## **REQUEST FOR FEE PROPOSAL for Landscape Architecture or Professional Engineering Services**

### **Flagstaff Hill Pathway and Entrance Improvements Schenley Park, Pittsburgh, PA**

#### **-ADDENDUM No. 1-**

Issued: February 13, 2025

**FLAGSTAFF HILL EXISTING CONDITIONS SURVEY**  
Scale: 1" = 50'-0"

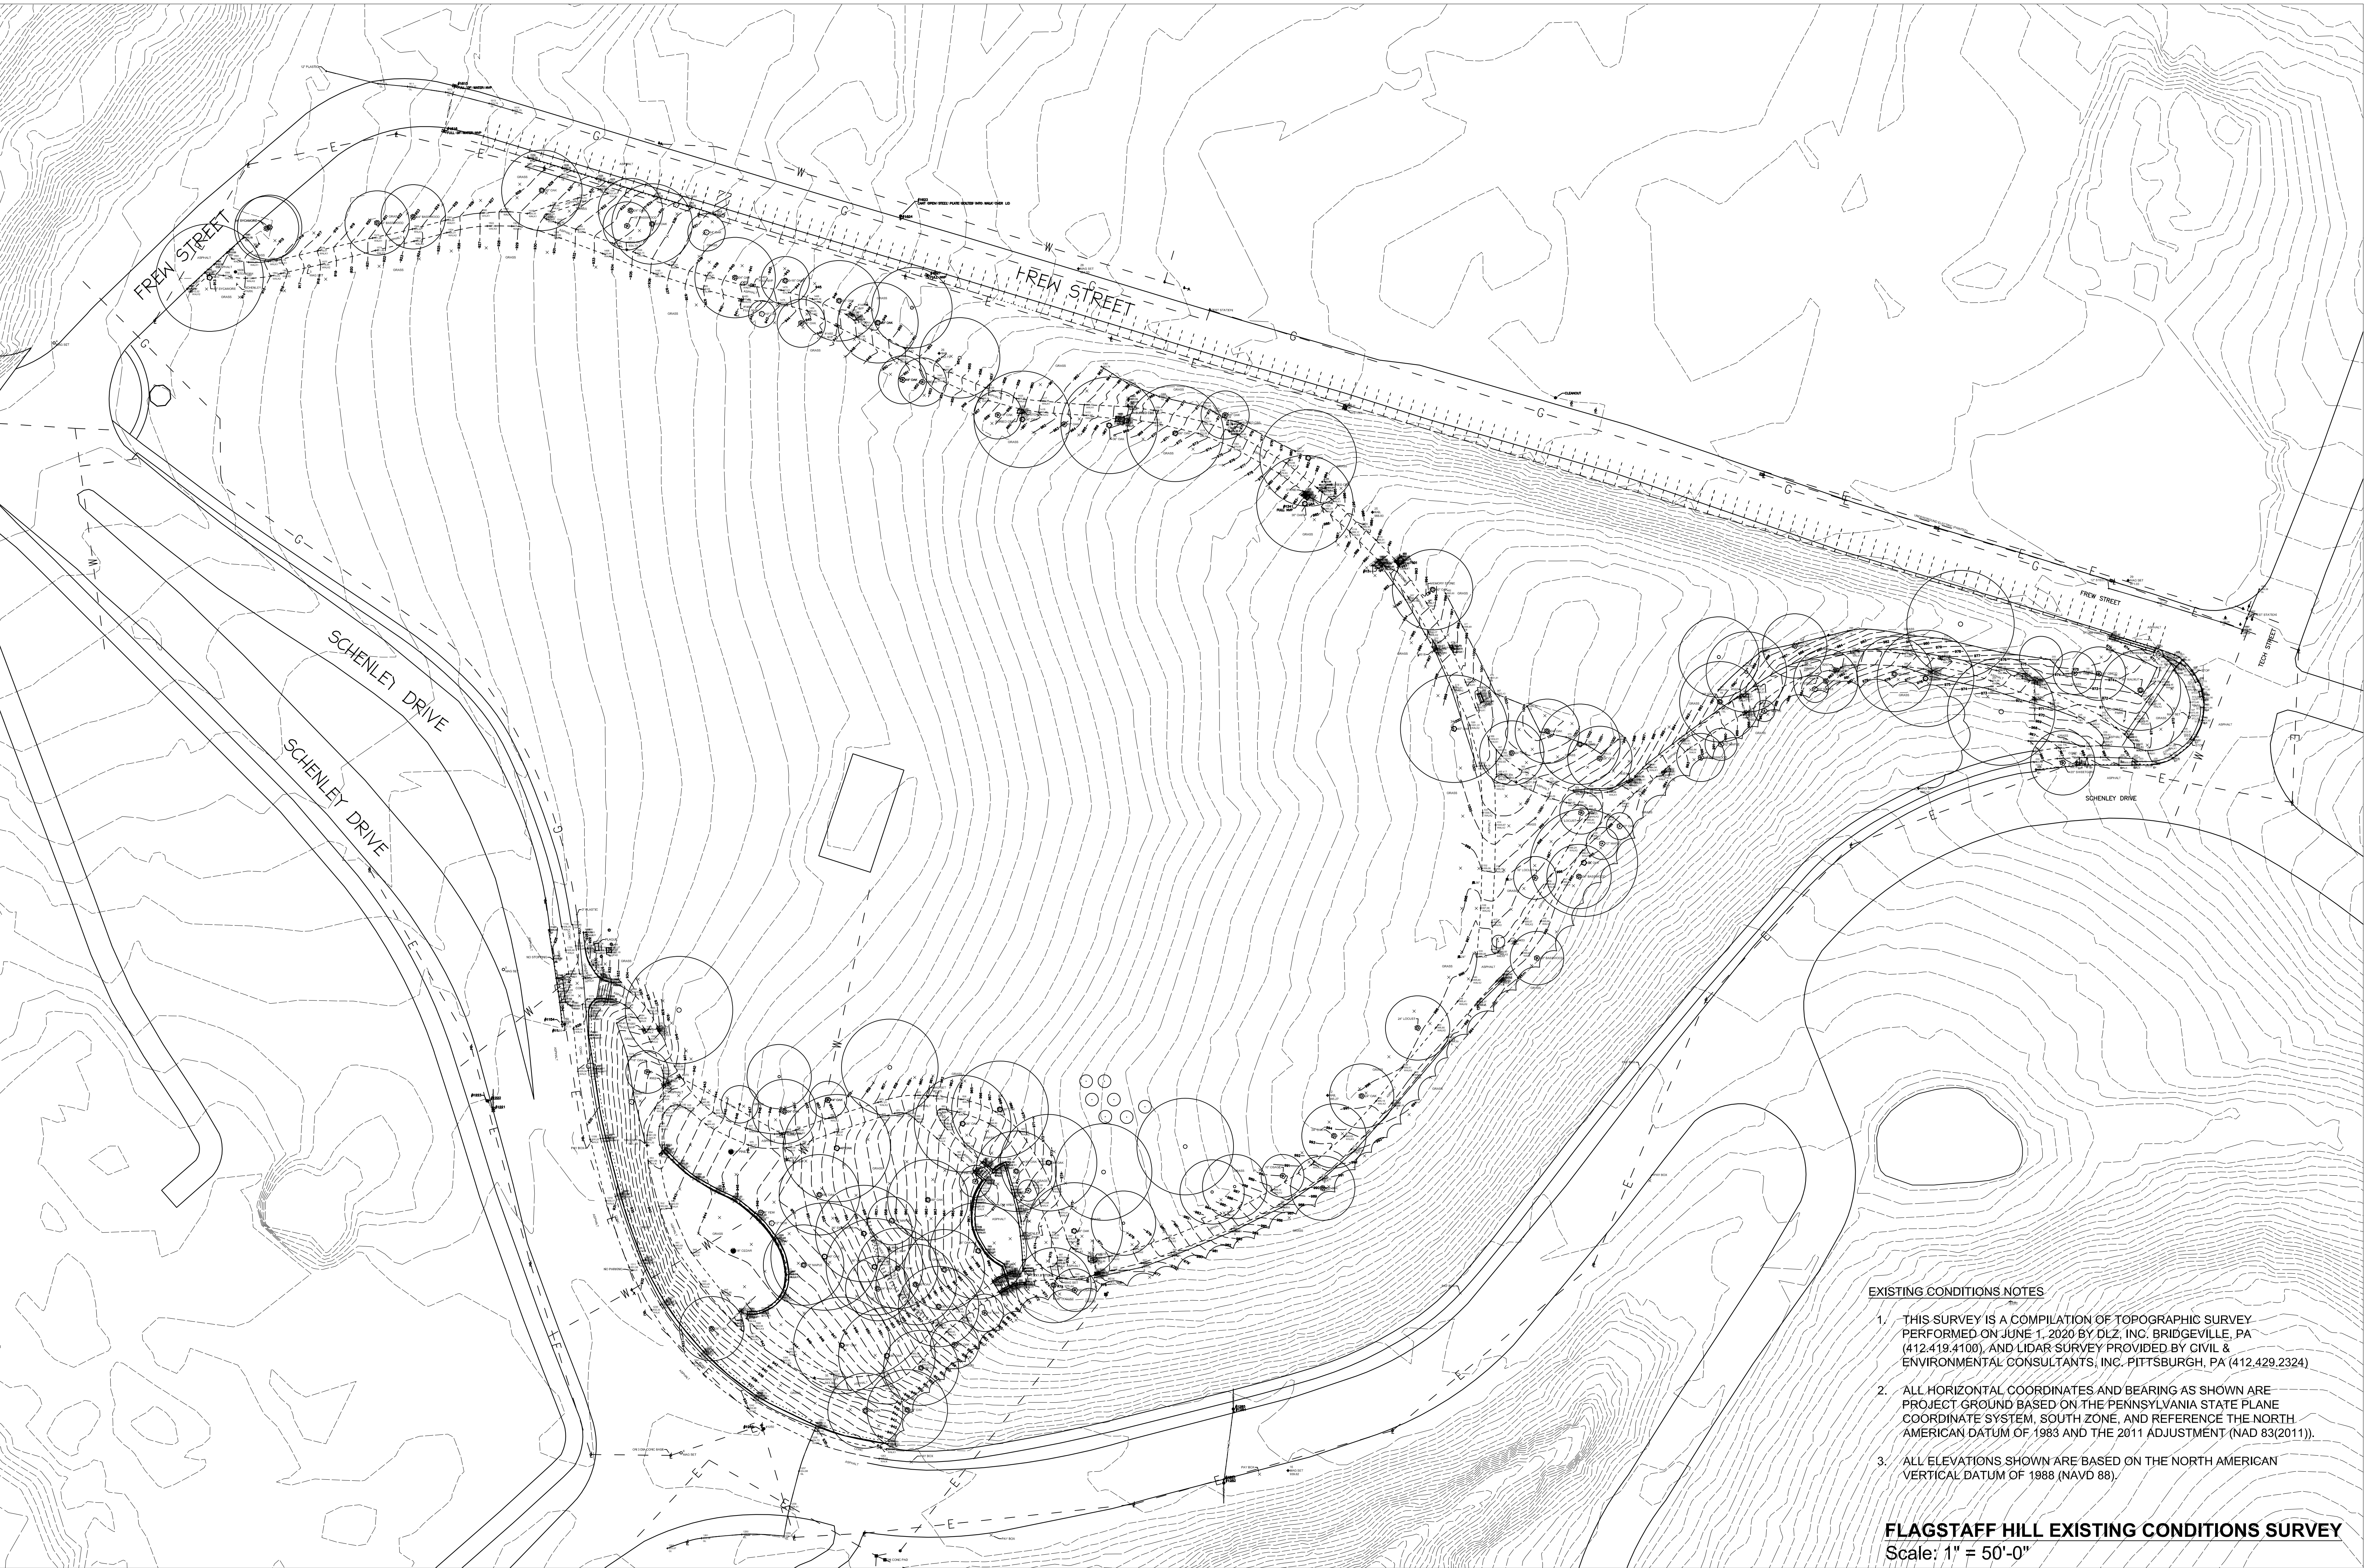
**Question 1:** *Can PPC provide a copy of the topographic survey?*

- Question 15:** *When was the topographical survey completed?*
- Response:** **The Existing Conditions Survey included in this Addendum is a compilation of topo survey performed on June 1, 2020 and LIDAR.**

**Question 20:** *Is the City/PPC able to provide documentation of existing utility lines, or is this assumed to be part of the Consultant's scope?*

**Response:** **Yes, see attached Exhibit “Flagstaff Existing Conditions Survey” (2020).**

**Response:** **This Addendum includes an Existing Conditions Survey (topographic survey) completed in 2020. The ECS includes limited information re: existing utility infrastructure. The Consultant may wish to recommend supplemental and topo and utility surveys are performed within the supplemental engineering allowance or main project fee.**
